City of Sebastopol Design Review Board/Tree Board Staff Report

Meeting Date: November 26, 2024
Agenda Item: 6A
To: Design Review and Tree Board
From: John Jay, Associate Planner

Applicant/Owner: Kathy Austin/Pacific Realty Development
File Number: 2023-078
Address: 7621 Healdsburg Ave
CEQA Status: Exempt
General Plan: High Density Residential/Commercial Office
Zoning: Multi-Family Residential (R7)/Office Commercial (CO)

Client: City of Sebastopol Planning Department
Project Location: 7621 Healdsburg Ave, Sebastopol, CA
Inspection Date: November 20, 2024
Arborist: Ben Anderson

TREE LOCATION AND NUMBERING PLAN
7621 HEALDSBURG AVENUE
SEBASTOPOL, CA

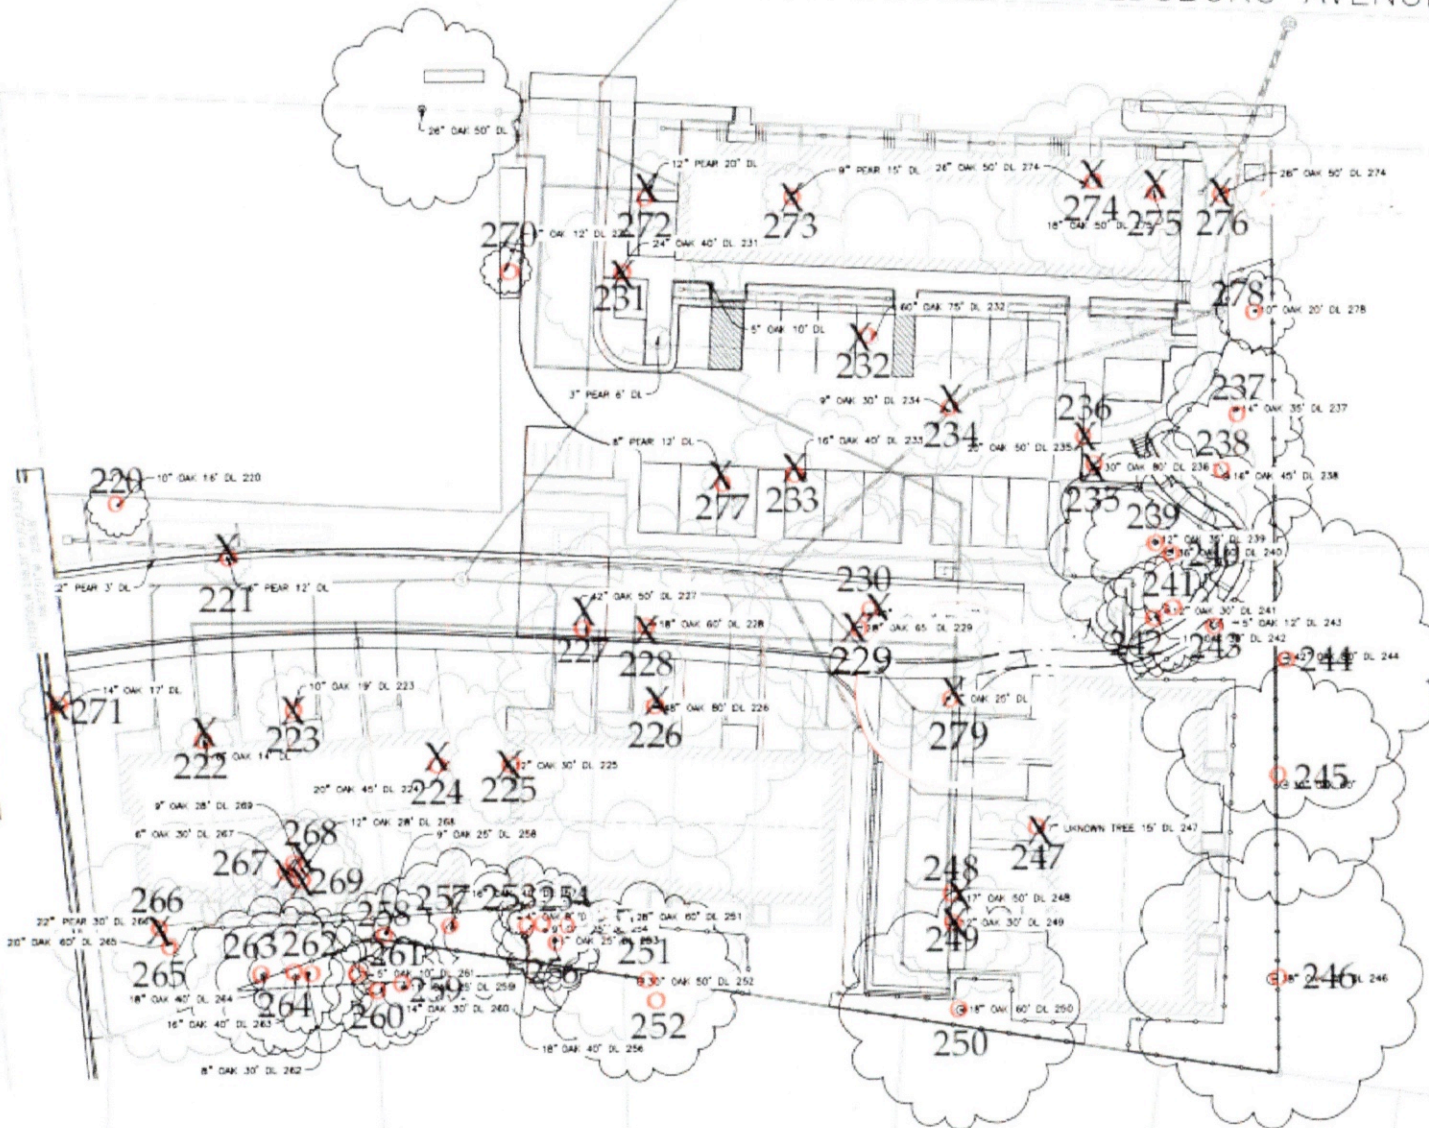
- The tree protection plan sheet should be updated to show the tree numbers relative to the arborist inventory.
- The tree protection plan sheet should be updated to show clear Xs on trees to be removed, including 239.

- Tree 265 should be marked as a removal in the arborist report or not marked as a removal on the plan sheets. I considered it a removal for this review.

- Tree 276 was removed and should be taken out of the inventory and removed from the plan set on all sheets.
- All sheets should be consistent with the Arborist Report. All should be updated to reflect the true number of protected tree removals.

10. The Developer shall provide an updated arborist report to reflect the current plan set. Tree diameters close to 10 inches should be updated to verify that they still do not qualify as protected trees.
11. The Developer shall provide a tree protection plan sheet that is updated to the current plan and show details and locations for tree protection measures recommended in the arborist report prior to building permit issuance.
12. The Developer shall provide an updated tree protection plan sheet to show clear Xs on trees to be removed, including tree #239.
13. The Developer shall include language from Section 8.12.050 on all applicable plan sheets
